Planning Commission Agenda July 16, 2019

RE: New Horse Barn Project

RE: 37 North Parking Lot Project

RE: Wells Apartments Project

5160 BARKER ROAD JONESVILLE, MICHIGAN 49250 www.stollcm.com TEL. 517.212.0405 DRAWING TITLE PITTLE SHEET

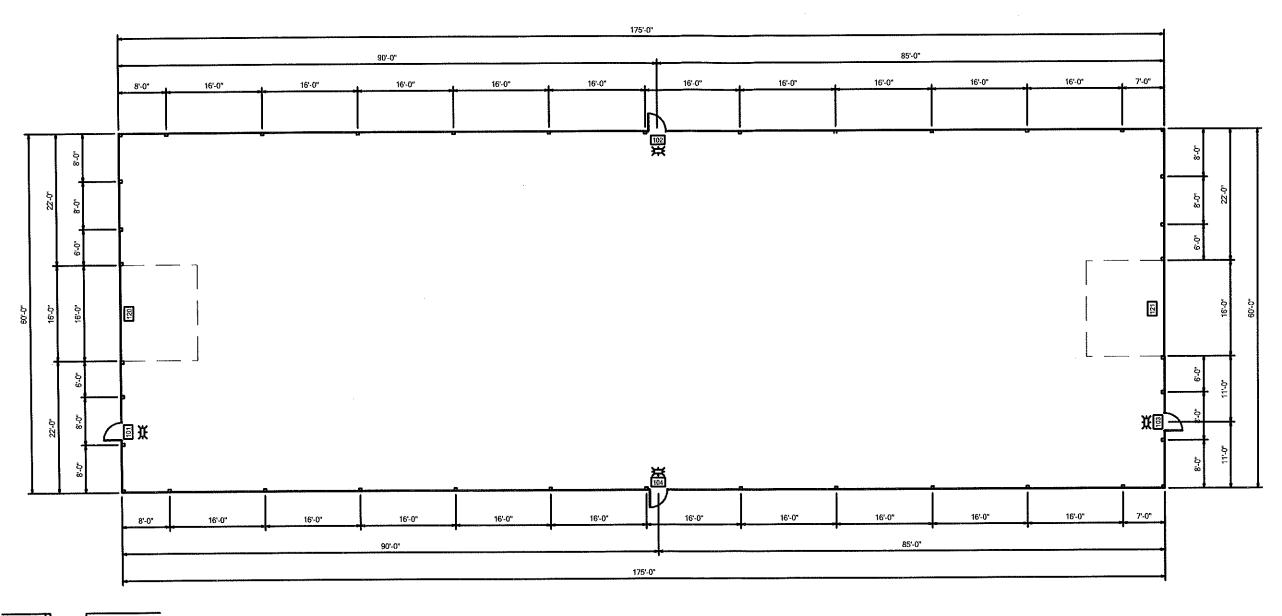
- Show MDOT Storm Water Easement on drawing.
- Show Storm Water notes on drawing.

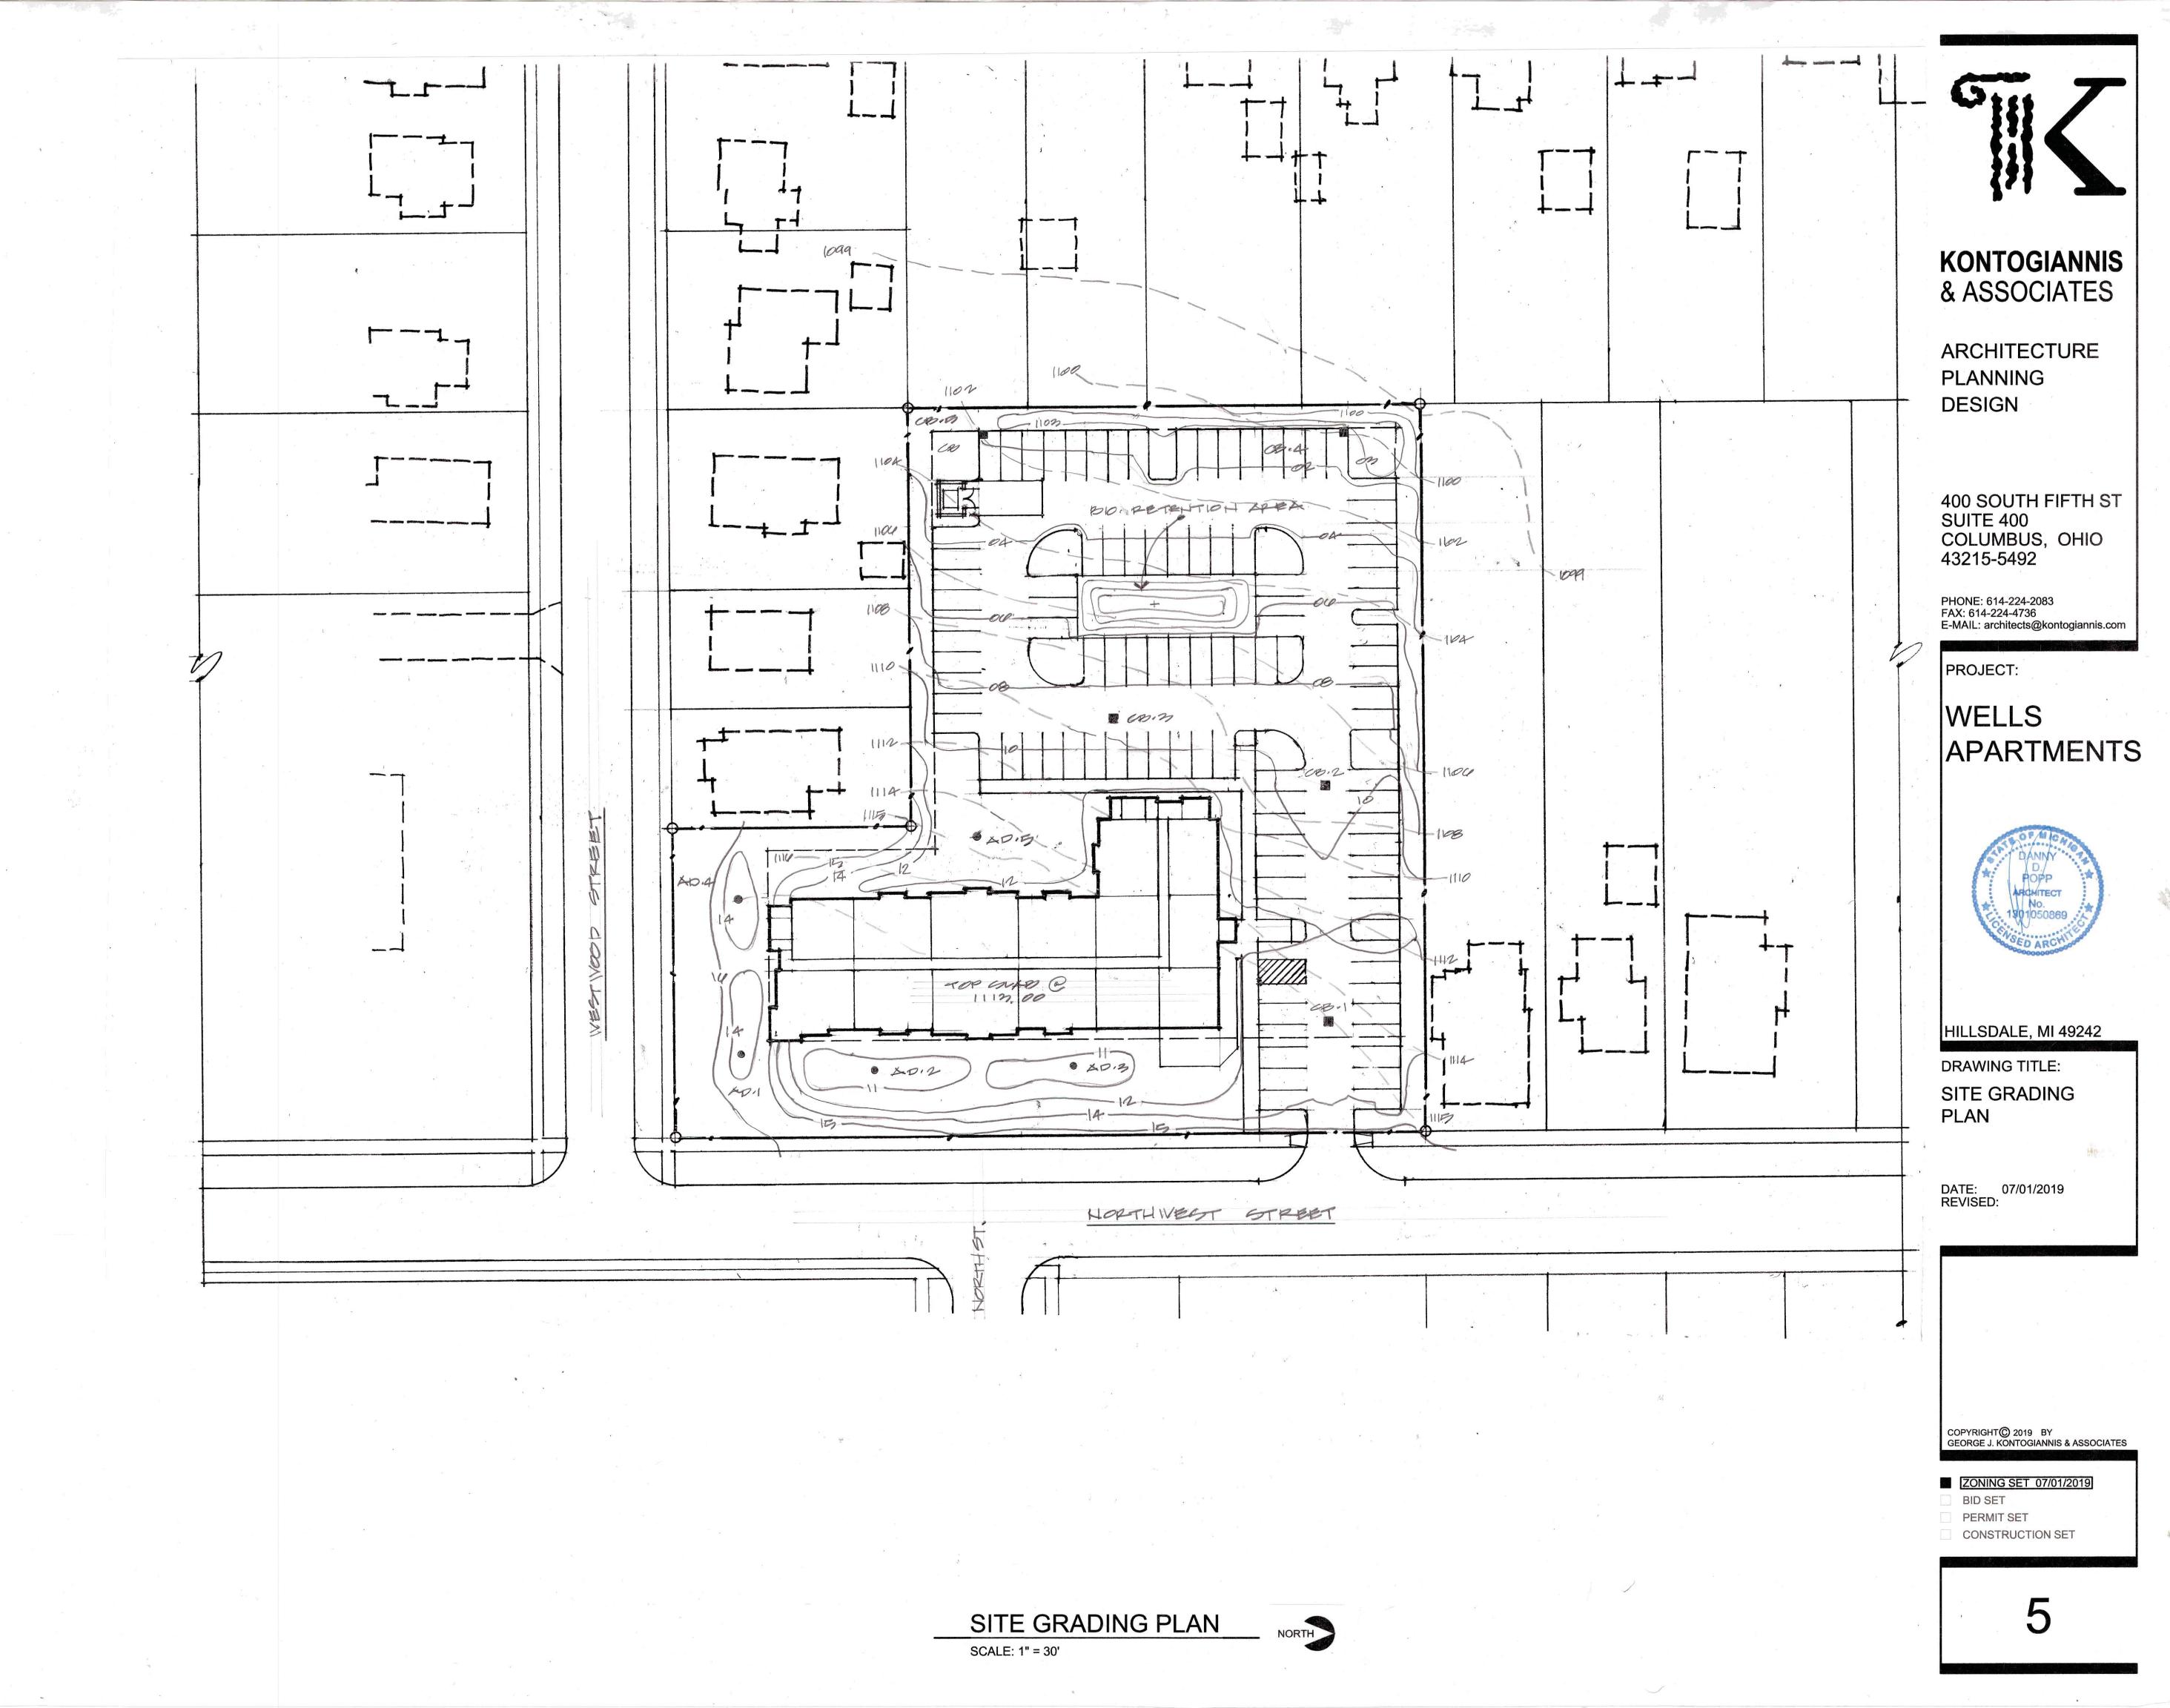
- Add notes to drawings re: BPU and MDOT specifications.
- Include site lighting plan and photometrics.

- New ADA compliant sidewalk to be installed along N. West and Westwood St. frontages.
- Drive Approaches to be MDOT "M" style.
- All Street Dept. details to be MDOT specified.

- Building Fire Protection connections to be "Y" style Siamese.
 - o Specify clearances at connections on drawings.

- Demolition
 - o Remove abandoned utilities back to mains and repair right-of-way.
- BPU to perform flow test on adjacent fire hydrants and send results to Architect.
- BPU to send City Standard specifications to Architect.
- Show new sanitary line on drawings.
- Elec. Service to be 3 ph. 120/208/3ph available at southeast pole on site.
